OIL INDIA LIMITED
(A Government of India Enterprise)
P.O. Duliajan, Pin – 786602
Dist-Dibrugarh, Assam

Corrigendum No. 2 dated 06.05.2020 to E-Tender No. CDG4164P21 for hiring services for acquisition of 200 LKM of 2D and 185 SQKM of 3D seismic data in the OALP-III Block: AA-ONHP-2018/5 and its adjoining areas in the state of Tripura.

Figure 1

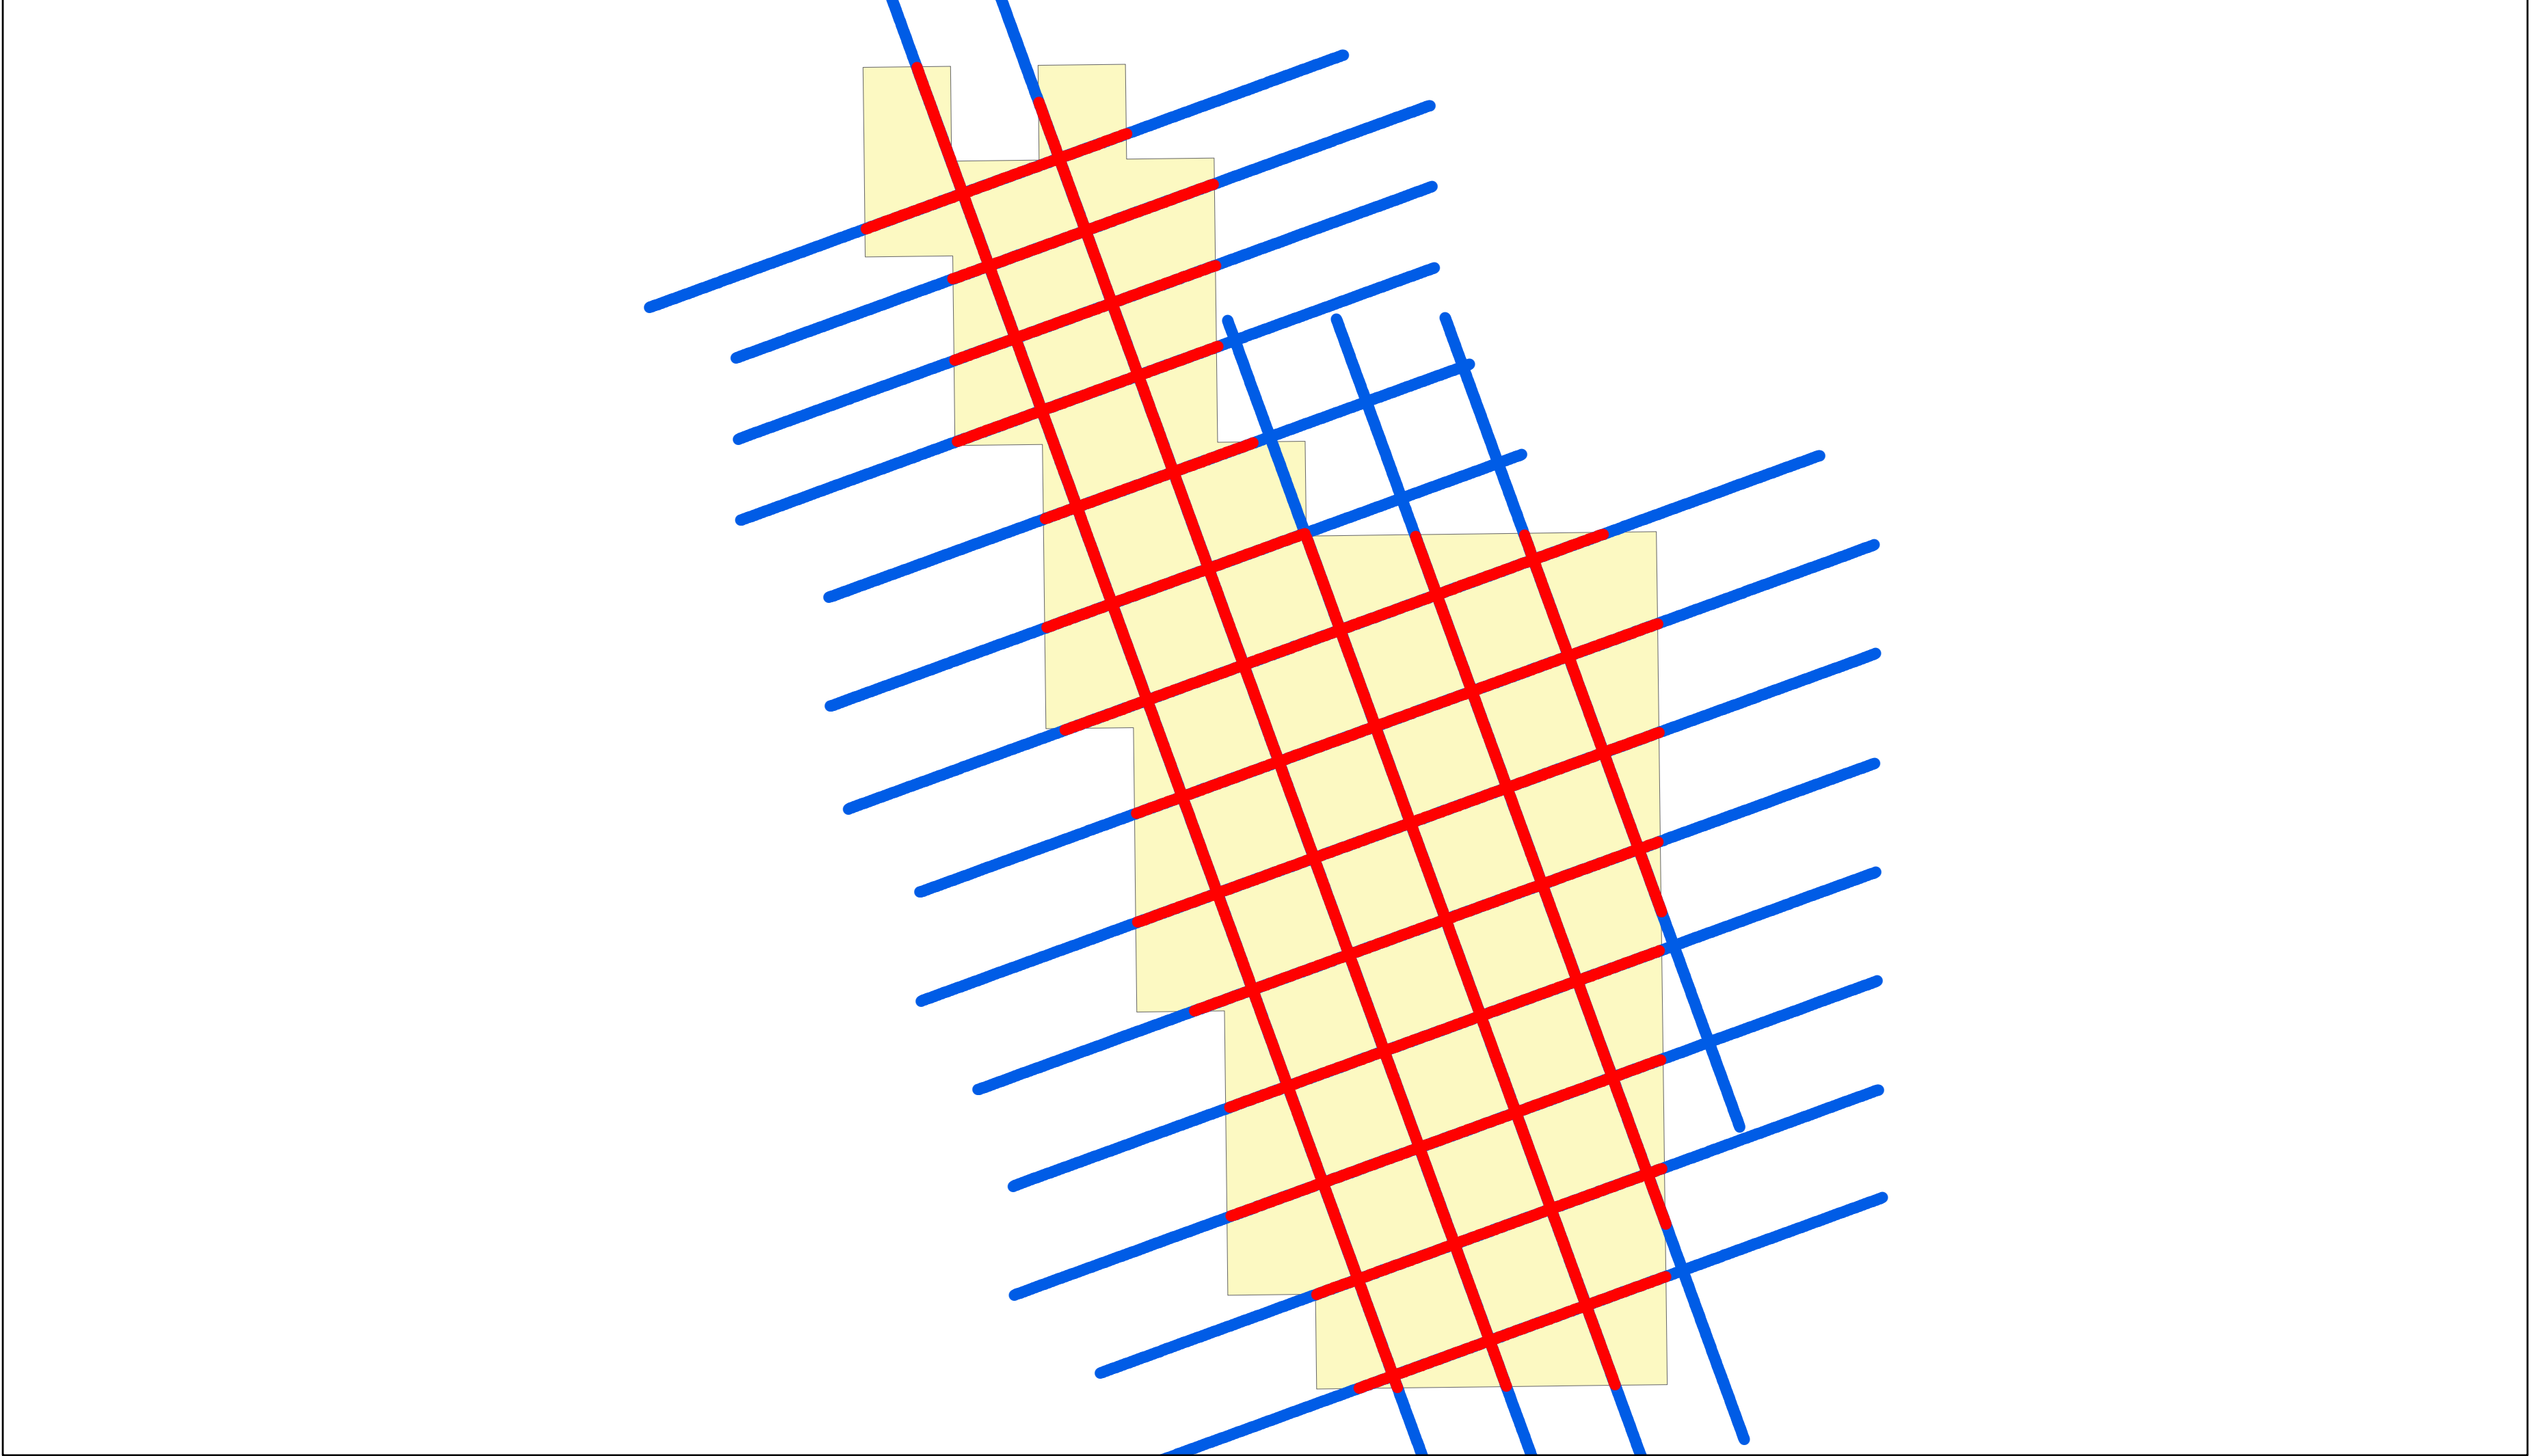
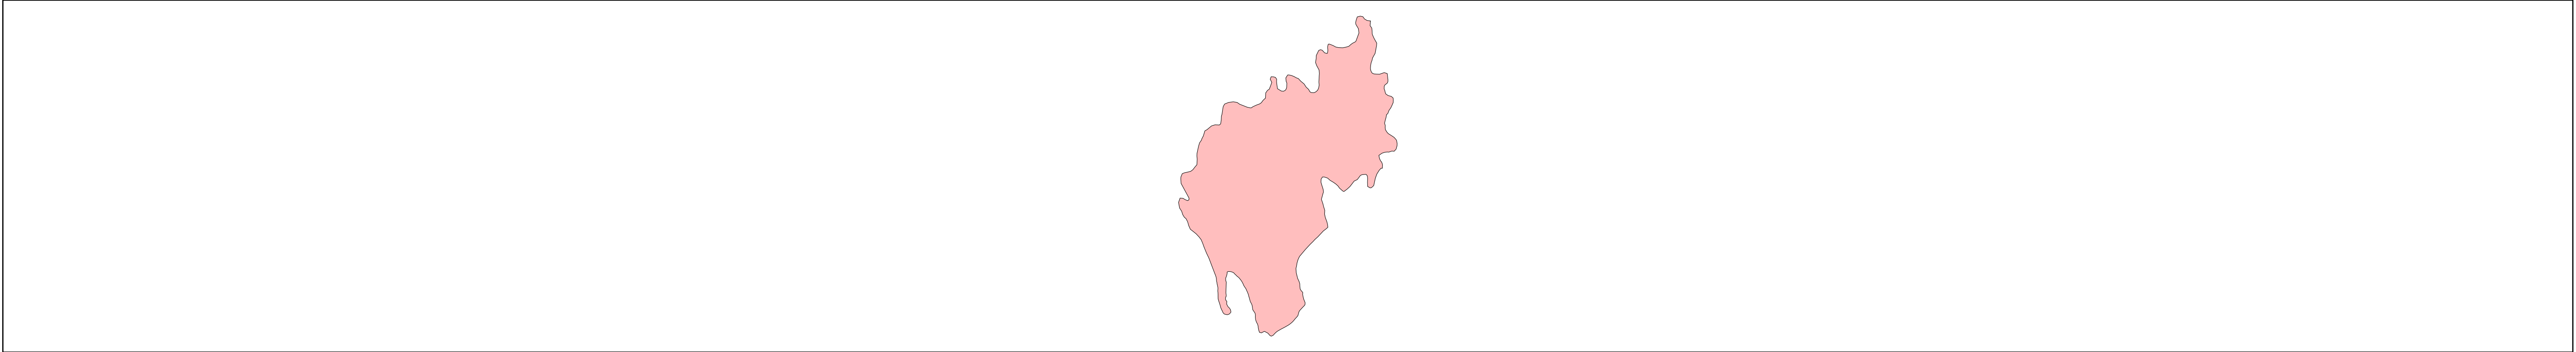
10. Bidders may refer to **Figure1** (Proposed 2D Block AA-ONHP-2018/5) and **Forest Cover Map** of the Block enclosed herewith.
-
